JURATEK

DAF11D

to fit: **DAF:** XF95, 105 series, CF65, CF75, CF85 series
FODEN: Alpha series

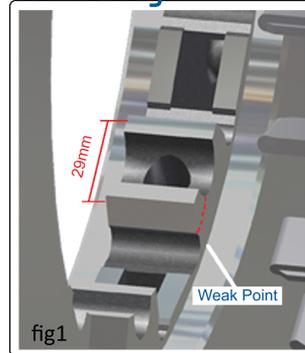
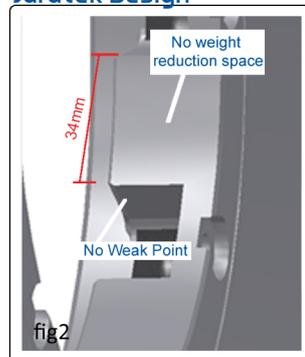
The original design has 20 intermediate spacers that can be difficult to install and even more difficult to remove along with a further 10 spring washers.

Juratek have increased the size of the intermediate splines and replaced the 10 spring washers with one integrated fixing ring.

This new design also gives added strength to the intermediate splines. This increased strength comes from the intermediate splines being increased in width and the weight reduction space being filled. (see fig 1 & 2)

This can prevent the splines from separating from the disc when under stress.

New Development 2016

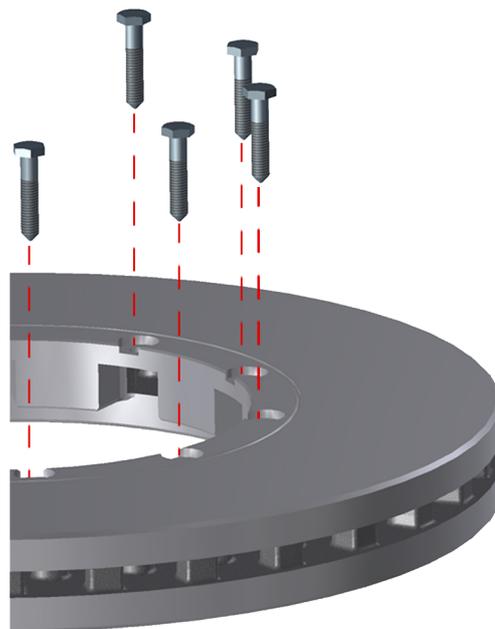
A further development has been made to further simplify the fitting of the disc to the hub. Instead of a separate fitting ring (which allows for further wear to the hub), the fitting ring is now cast as part of the disc itself.
